GPI-1680 ROLL-ON FINISH COMPATIBLE WITH STEL® CAPSULES

TECHNICAL BULLETIN

This bulletin is to inform you of the revision to the standard GPI-1680 glass finish specification. This revision as outlined below allows the glass container manufacturers to work to and provide their customer base one standard finish construction for both Liquor and Wine end use containers.

FIGURE 2

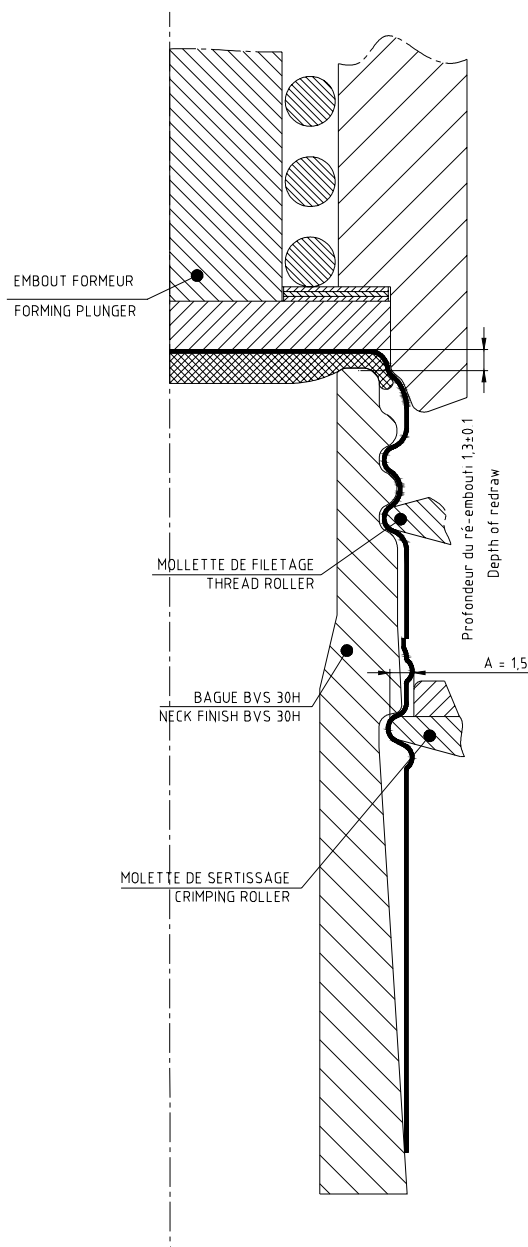
The "S" and "H" dimensions for the Wine finish (BVS) have also been increased .045" [1.15 mm] and .041" [1.05 mm] respectively to allow the pressure block to form the side seal without interfering with the thread start and also maintaining sufficient thread travel and engagement. See Figure 2.

Edward A. Grant CHAIRMAN	PRINTED AND DISTRIBUTED AS A VOLUNTARY STANDARD BY GLASS PACKAGING INSTITUTE COMMITTEE ON DESIGN AND SPECIFICATIONS	APPROVED FOR PUBLICATION 6-15-05	SUPERSEDES DWG. NO. 16802
	Karl Reisig SECRETARY	GLASS FINISH NUMBER 1680	GPI DWG. NO. 1680-03

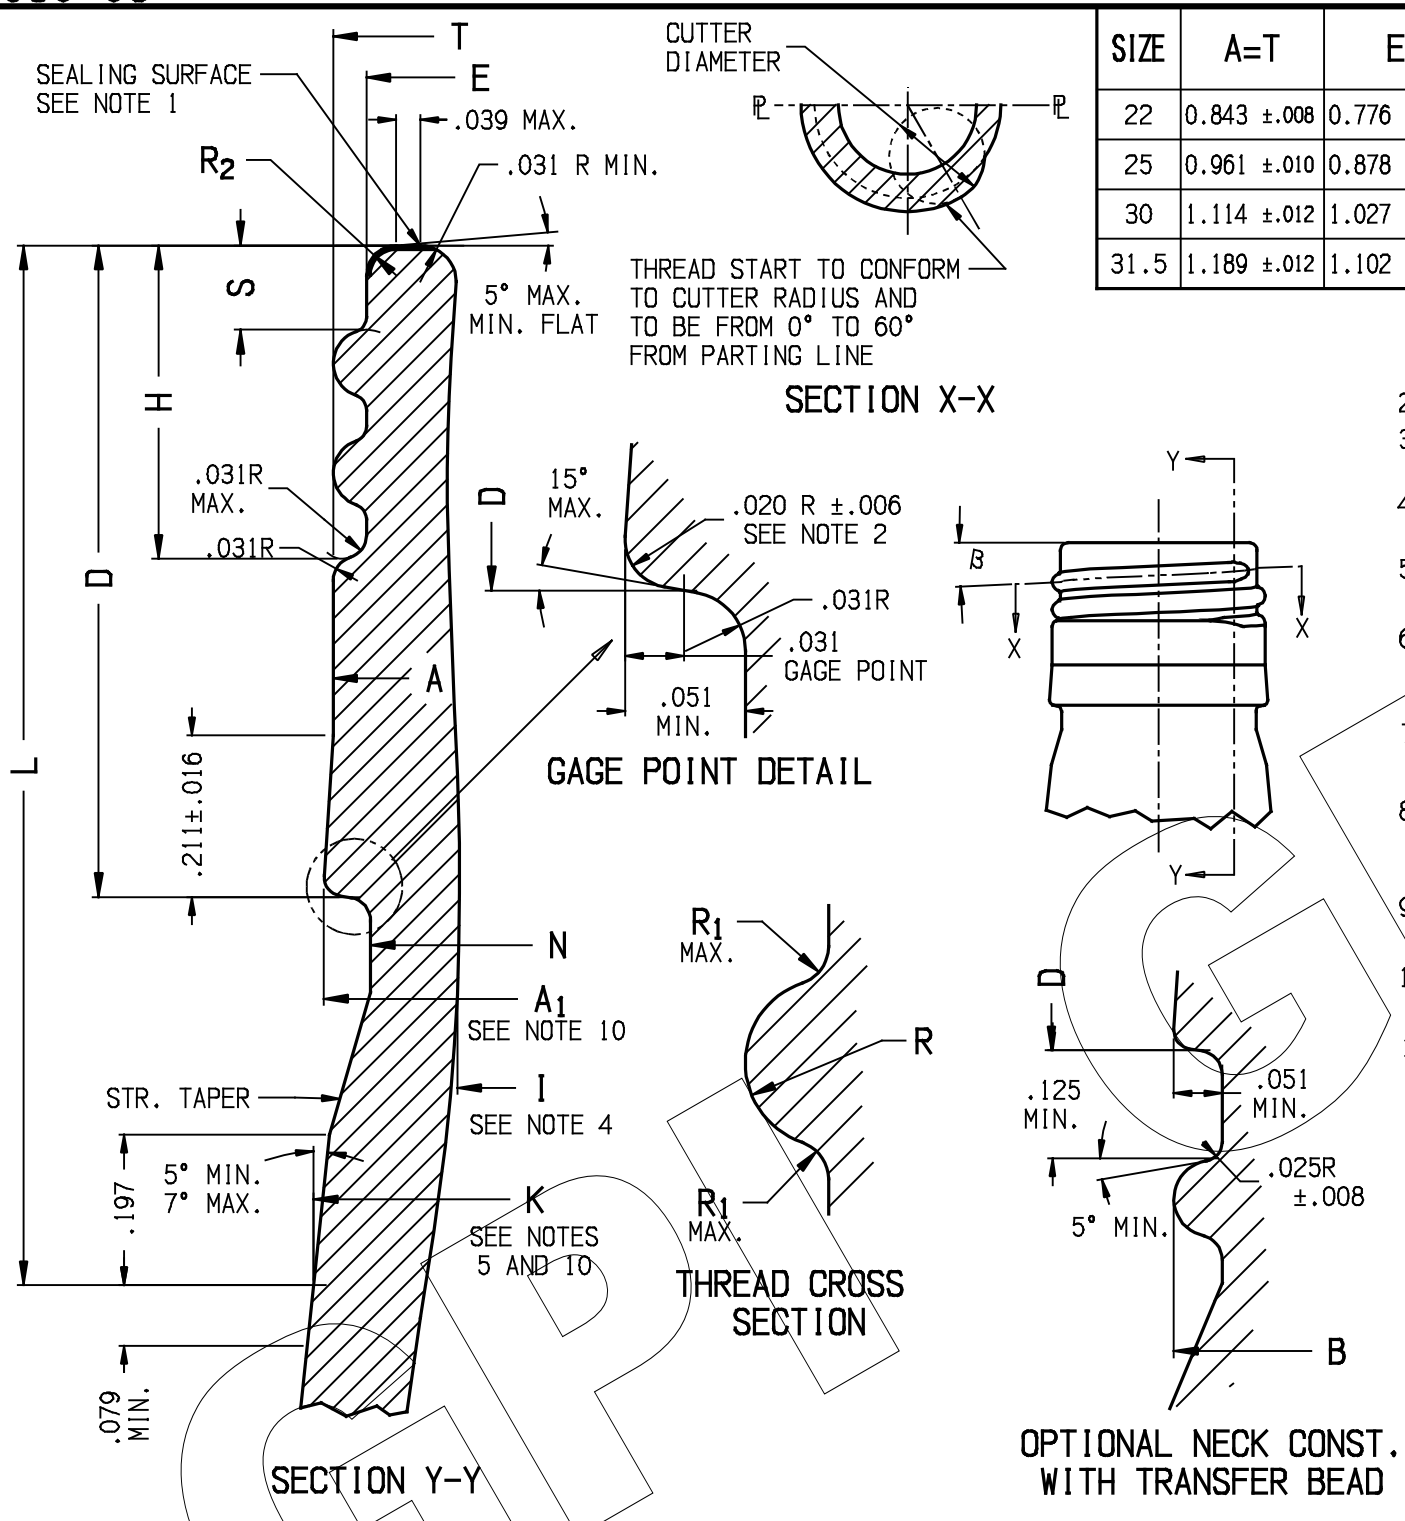
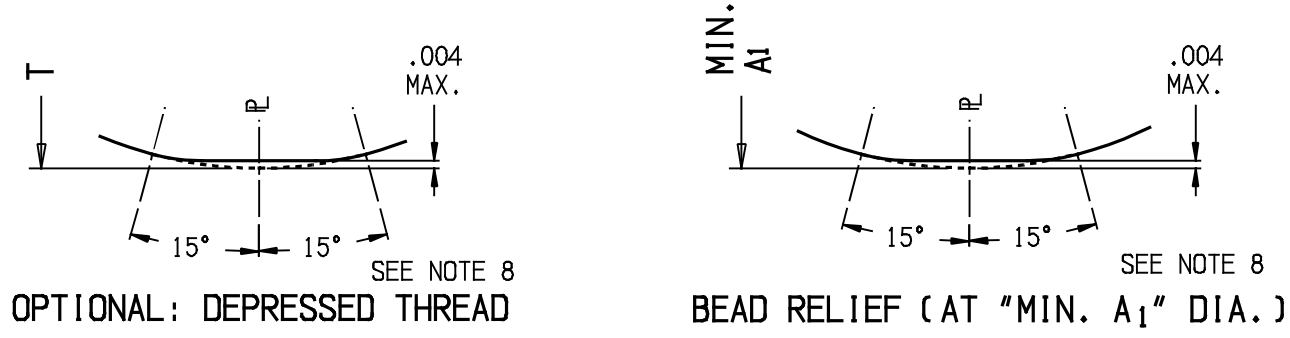
These major revisions are on the attached GPI-1680 drawing, 1680-03, dated 06/15/2005 and are as follows:

"S" dimension revised to .110" [2.79mm] from .065" [1.65mm] on sizes 30 mm diameter and above.

"H" dimension revised to .409" [10.39mm] from .368" [9.35mm] on sizes 30 mm diameter and above.

"L" dimension increased .020" [.51mm] on sizes 30 mm diameter and above, along with neck angle controls at the "K" diameter.

For Wine end use the top and side seal pressure block is necessary and is the only new part that is required on the capping head. Current capping head thread rollers will need to be adjusted .045" [1.15 mm] for the proper location on the revised finish. For Wine containers, the vertical load pressure on the top of the closure is 360 lbf ± 40 lbf on the 30mm and 31.5mm sizes.

For Liquor end use the top seal pressure block will not need to be replaced but the current capping head thread rollers will need to be adjusted .045" [1.15 mm] for the proper location on the revised finish. For Liquor containers, the vertical load pressure on the top of the closure is 270 lbf ± 40 lbf on the 30mm and 31.5mm sizes.
